CITY PLANNING COMMISSION

- APPLICATION:
1. Environmental Determination
 2. Special Permit to develop two 65 foot buildings of 72,000± and 78,000± square feet on 8+ vacant ac. zoned Office Building-Planned Unit Development (OB-PUD)

APPLC. NO. P83-429

CPC ITEM NO. 21

EAST ELEVATION

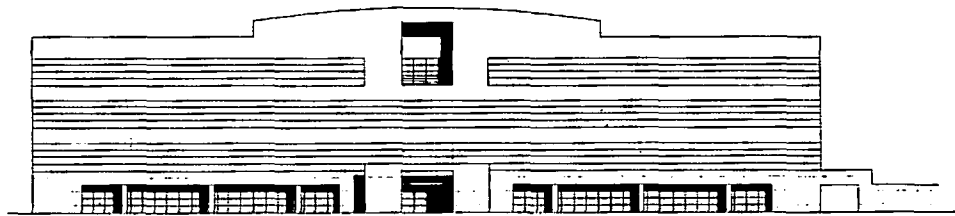
The Commonwealth Office Building is designed in a similar architectural style, but is more austere. The staff has concerns regarding the design of the north and east elevations as these facades will be closest to and in clear view from the I-5 Freeway and Garden Highway Freeway off ramp.

The Commonwealth Building, as in other contemporary buildings using a similar design approach, tends to appear overly sterile. Staff feels that a change in surface plane would alleviate this problem. The project architect should consider alternative design treatment of the north and east elevations to provide more interest and similar fenestration to the south and west facades. The staff suggests several alternatives, but is not limiting design modifications to only these alternatives:

- a. The horizontal window lines could be recessed in order to cause a change in surface plane creating a shadow line at each floor level and a break in the straight vertical line at each corner;
- b. Incorporate an undulating window band found on the south elevation at the northeast corner of the building;
- c. Incorporate a semi-rounded projection similar to the State Fund Building at the northeast corner of the building at one or more floor levels.

- a. The following revisions shall be incorporated into the building permit plans prior to issuance of building permits:
 - 1) A 50-foot building and landscape setback along Gateway Oaks Drive;
 - 2) Pedestrian walkways connecting the buildings, parking areas and streets;
 - 3) Detailed plans for the bicycle and trash enclosure facilities as specified in the staff comments (ref. comments #5 & #6);
 - 4) Outdoor lighting plan as specified in the staff comments (ref. comment #7).
- b. The applicant shall submit design modifications to the Commonwealth Building, specifically the north and east elevations, to the Planning Director for review and approval prior to issuance of building permit. The applicant shall consider staff suggestions to modify the structure as discussed in staff comments (ref. comment #2), but is not limited to these alternative design solutions;

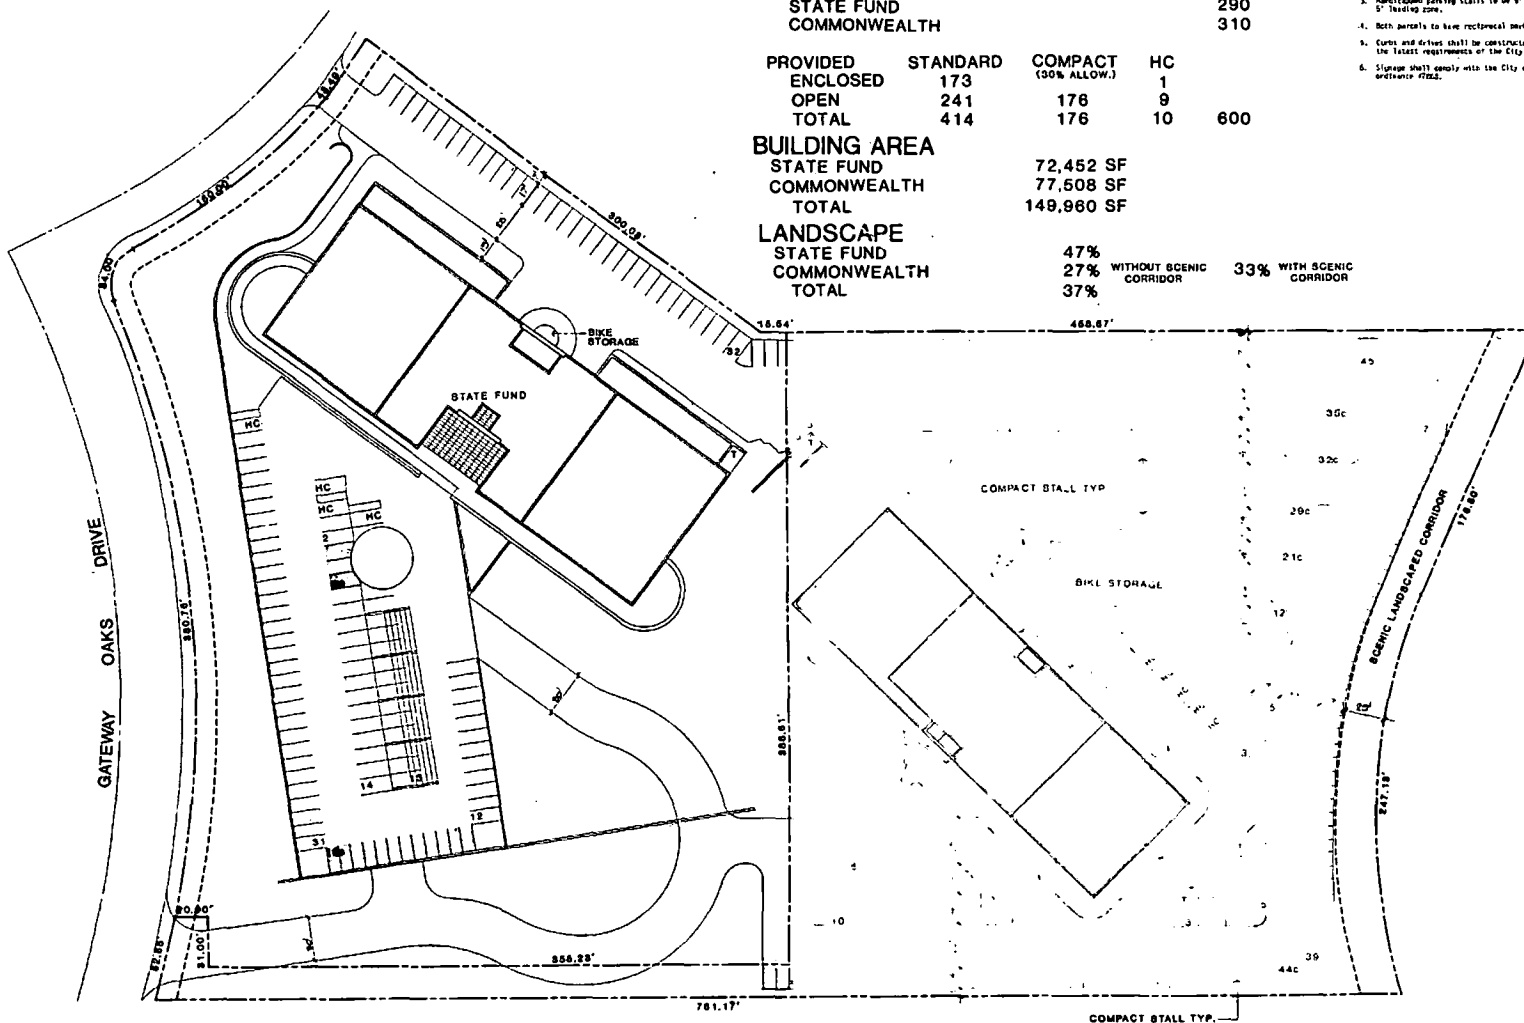
The site plan indicates a 50-foot building setback along Gateway Oaks Drive per the PUD development guidelines, but the drawing scales out to 40 foot setback. The applicant is aware of the discrepancy and is revising the site plan to comply with the PUD building and landscape setback requirements along Gateway Oaks Drive.
